10/803,779

Hirofumi Harada

Office Action Summary

FIG. 2 (PRIOR ART)

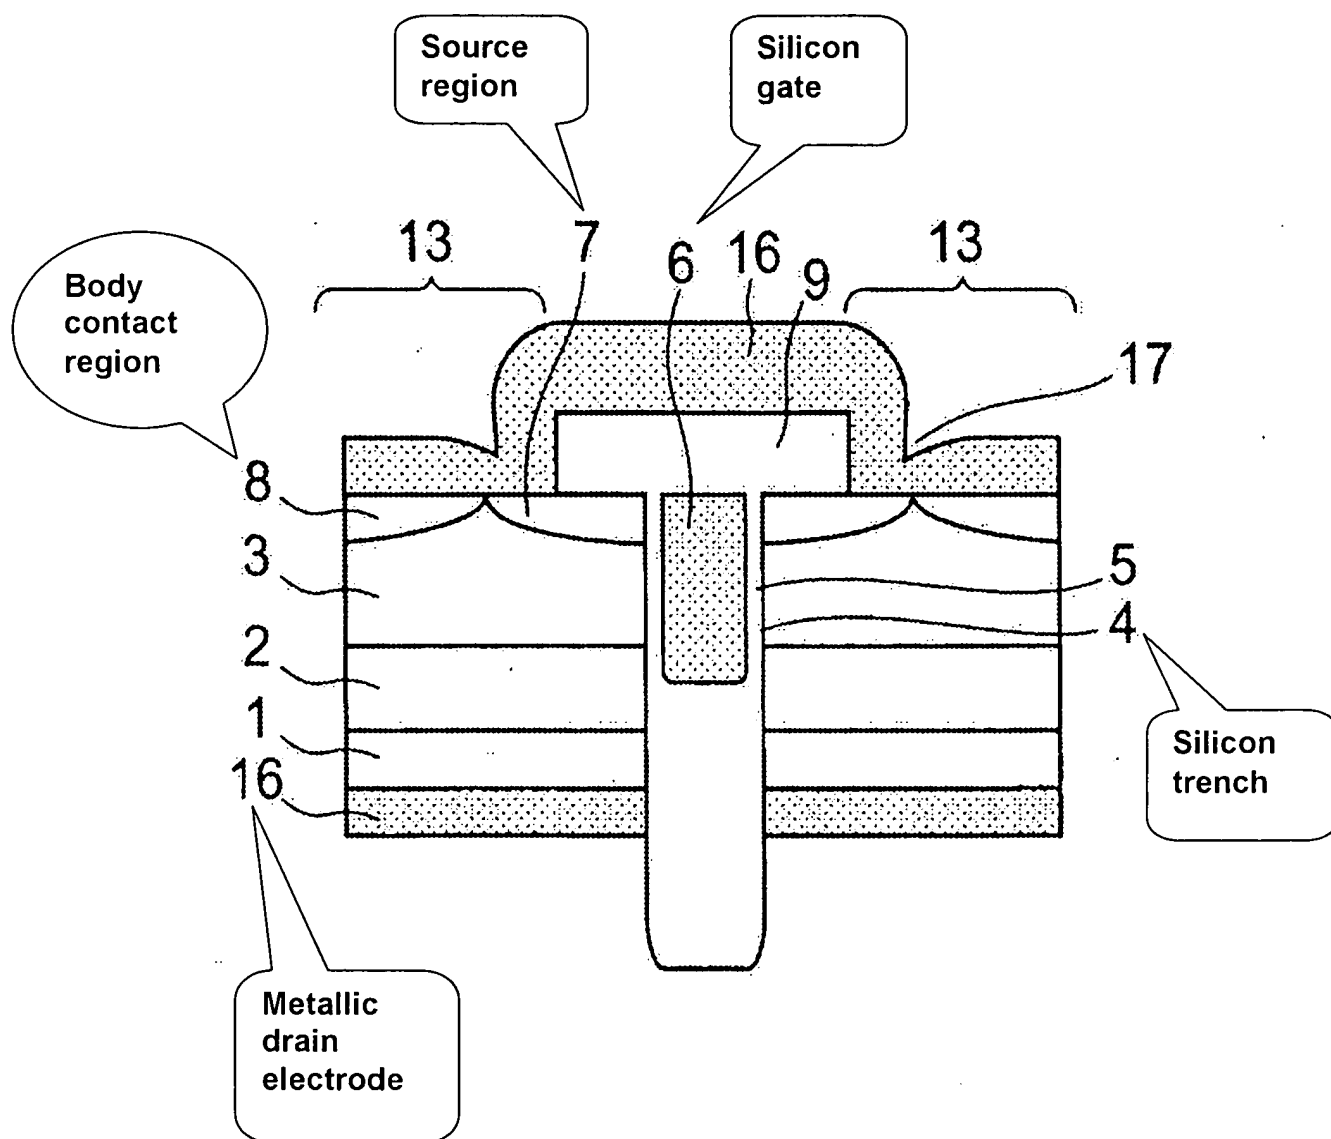
1. Figure 2 should be designated by a legend such as **--Prior Art--** because only that which is old is illustrated. See MPEP § 608.02(g). Corrected drawings in compliance with 37 CFR 1.121(d) are required in reply to the Office action to avoid abandonment of the application. The replacement sheet(s) should be labeled "Replacement Sheet" in the page header (as per 37 CFR 1.84(c)) so as not to obstruct any portion of the drawing figures. If the changes are not accepted by the examiner, the applicant will be notified and informed of any required corrective action in the next Office action. The objection to the drawings will not be held in abeyance.

Regarding claim 1, APA (Fig. 2) discloses a vertical MOS transistor comprising: a semiconductor substrate 1 of a first conductivity type (see Specification, page 1, lines 10-11); an epitaxial growth layer 2 of the first conductivity type which is formed on the semiconductor substrate 1 (see Specification, page 1, lines 8-11); a body region 3 of a second conductivity type which is formed on the epitaxial growth layer 2 (see

Specification, page 1, lines 14-17); a heavily doped body contact region 8 of the second conductivity type which is formed on a part of a surface of the second conductivity type body region 3 (see Specification, page 1, lines 18-21); a heavily doped source region 7 of the first conductivity type (see Specification, page 1, lines 18-20), which is formed on a part of the surface of the second conductivity type body region that is covered with the heavily doped body contact region 8 (see Fig. 2 labeled by the examiner below); a silicon trench 4 piercing the second conductivity type body region 3 and the first conductivity type source region 7 to reach an inner part of the first conductivity type epitaxial growth layer 2 (Specification, page 2, lines 6-8); a gate insulating film 5 formed along walls and bottom of the silicon trench 4 (Specification, page 2, line 8); a heavily doped polycrystalline silicon gate 6 buried in the silicon trench 4 while surrounded by the gate insulating film 5 (Specification, page 2, lines 8-10); an intermediate insulating film 9 formed on the polycrystalline silicon gate 6 in the silicon trench 4 to reach a surface the semiconductor substrate 1; a metallic source electrode 16 being in contact with the intermediate insulating film 9, the heavily doped source region 7, and the heavily doped body contact region 8; and a metallic drain electrode 16 connected to a rear surface of the semiconductor substrate 1 (see Fig. 2 labeled by the examiner below).

APA does not disclose a heavily doped polycrystalline silicon gate 6 buried in the silicon trench 4 to a level of the first conductivity type source region 7.
